**REVISED RESPONSE TO REQUEST FOR ADDITIONAL INFORMATION****APR1400 Design Certification****Korea Electric Power Corporation / Korea Hydro & Nuclear Power Co., LTD****Docket No. 52-046**

**RAI No.:** 208-8245

**SRP Section:** 03.08.03 – Concrete and Steel Internal Structures of Steel or Concrete Containments

**Question No. 03.08.03-5**

**Figure 3.8A-24 Solid, Shell, and Beam Element Model for RCB Internal Structure**

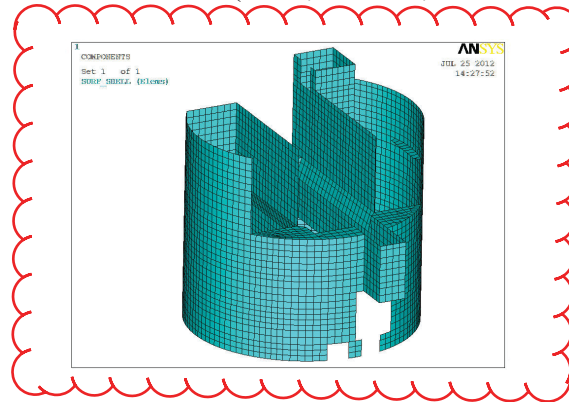
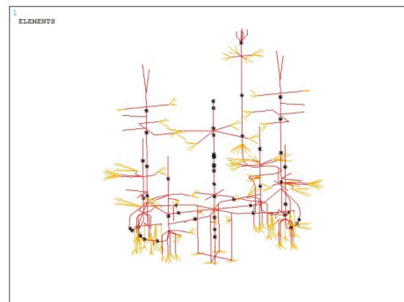
- c. This DCD Section also indicates that Figure 3.8A-23 shows the full FEM for the containment internal structures and Figure 3.8A-24 shows the solid element model (PSW, IRWST, and fill concrete), shell element model (SSW), and beam element model (RCS). The staff notes that part (b) of Figure 3.8A-24, which is labelled Shell Element Model (SSW), does not show the shell elements of the SSW. The applicant is requested to clarify why not.

- c. Part (b) of Figure 3.8A-24 shows the solid element model of the PSW, the IRWST, and the fill concrete due to an editorial error. In order to show the shell element model of the SSW, part (b) of Figure 3.8A-24 will be revised as indicated on the attached markup.
